UNITED STATES PATENT AND TRADEMARK OFFICE

APPLICATION NO.	FILING DATE	FIRST NAMED INVENTOR	ATTORNEY DOCKET NO.	CONFIRMATION NO.
10/709,846	06/01/2004	Ching-Huei Tsai	NAUP0572USA	3845
27765	7590	04/06/2006	EXAMINER	
NORTH AMERICA INTELLECTUAL PROPERTY CORPORATION P.O. BOX 506 MERRIFIELD, VA 22116				OWENS, DOUGLAS W
ART UNIT		PAPER NUMBER		
		2811

Office Action Summary	Application No.	Applicant(s)
	10/709,846	TSAI, CHING-HUEI
	Examiner Douglas W. Owens	Art Unit 2811

6. Applicant's amendment necessitated the new ground(s) of rejection presented in this Office action. Accordingly, **THIS ACTION IS MADE FINAL**. See MPEP § 706.07(a). Applicant is reminded of the extension of time policy as set forth in 37 CFR 1.136(a).

Regarding claims 1, 8, 9 and 11 Himes et al. teach a semiconductor wafer comprising (Fig. 8, for example):

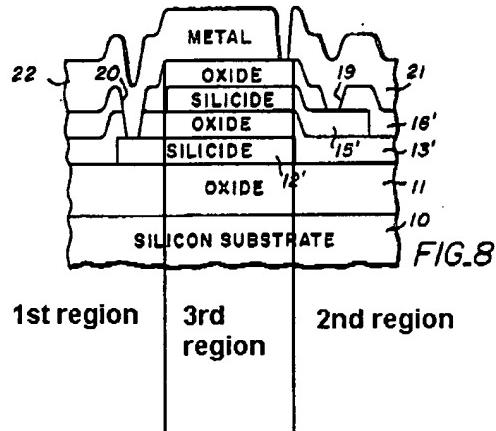
a substrate with a first region (pictured below and right), a second region, and a third region horizontally defined on the surface of the substrate; and

a capacitor disposed on the substrate, the capacitor comprising:

a first polysilicon electrode (12'; Col. 1, lines 8 – 12) in the first region and the third region;

a first isolation layer (13') on the first electrode, the first isolation

layer covering a portion of the first electrode and the substrate; and a second polysilicon electrode (15') on the first isolation layer, the second electrode covering the first electrode in the third region and covering the substrate in the second region.

Regarding claim 2, Himes et al. teach a semiconductor wafer, wherein the capacitor further comprises a second isolation layer (16') covering the capacitor and the substrate.

Regarding claims 3 and 12, Himes et al. teach a semiconductor wafer, wherein the capacitor further comprises a first contact plug (in via 20) located in the second isolation layer and electrically connected to the first electrode.

Regarding claims 4 and 13, Himes et al. teach a semiconductor wafer, wherein the first contact plug is located in the first region.

Regarding claims 5 and 14, Himes et al. teach a semiconductor wafer, wherein the capacitor further comprises a second contact plug (via 19) located in the second isolation layer and electrically connected to the second electrode.

Regarding claims 6 and 15, Himes et al. teach a semiconductor wafer, wherein the second contact plug is located in the second region.

Regarding claim 10, Himes et al. teach a semiconductor wafer, wherein the first isolation layer comprises silicon oxide.
